Authors' response (AC1) to the comments by Reviewer #1 (RC1)

Understanding the uncertainties of the runoff in the glacierised catchments and its impacts on the availability of water in Himalayan rivers is critical. This manuscript discussed the climate sensitive on variability and change of summer runoff in two glacierised Himalayan catchments. The authors argued that the runoff from the glacierised parts of the catchments is sensitive to temperature changes, but is insensitive to precipitation changes. With shrinking glacier cover over the coming decades, the summer runoff from the two catchments is expected become more sensitive to the precipitation forcing and less sensitive to the temperature forcing. These conclusion is clear and interesting, but not novel enough with comparison of the recent other researches. However, I still recommend this manuscript can be published.

Fig 1. A schematic representation of the modelling strategy used in the present study.

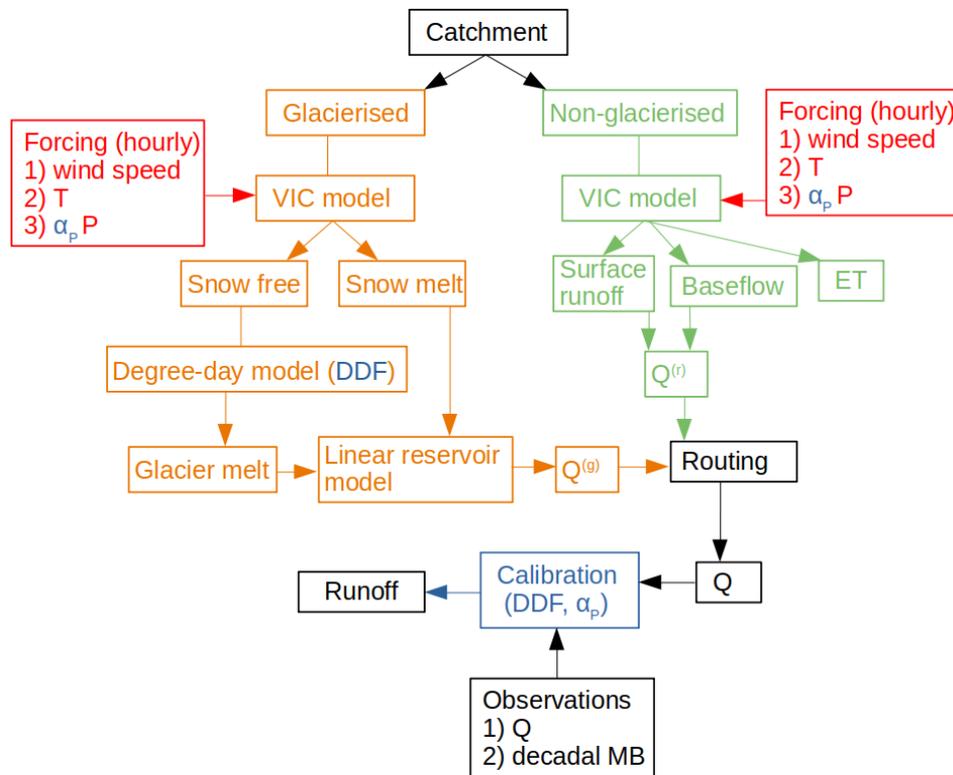
1. The description of the VIC model (including the input data, e.g. CMIP 5 data) is to simple toohelp for the reader to understand the article.
2. The authors did not considered the glacier volume change, then the conclusion is somewhat not convincible

1. We shall add additional details about the model and input data used. We shall add a flowchart to explain the model workflow better. The flowchart is added below. Please refer to AC2 for more details.
